**IEEE 802.11**  
**802 LAN Access Method for Wireless Physical Medium**

**DATE:** January 6, 1994

**TITLE:** EVALUATION OF THE DFWMAC

**Figure 1** Suggested alternate diagram for the DFW Protocol Stack shown in Figure 3-5 of P802.11-93/190.

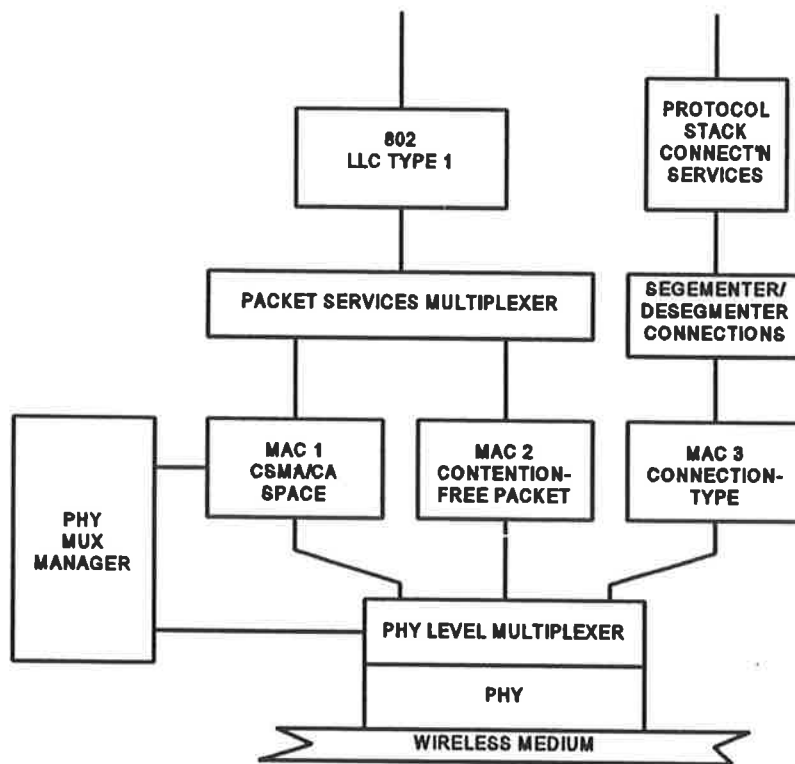
6. The MAC Service Model (Fig 3-5 of 93/190) does not correctly portray the function by over simplification. There is far less independence between the PCF and the minimal required functions than portrayed, and this difference will make implementation very difficult.
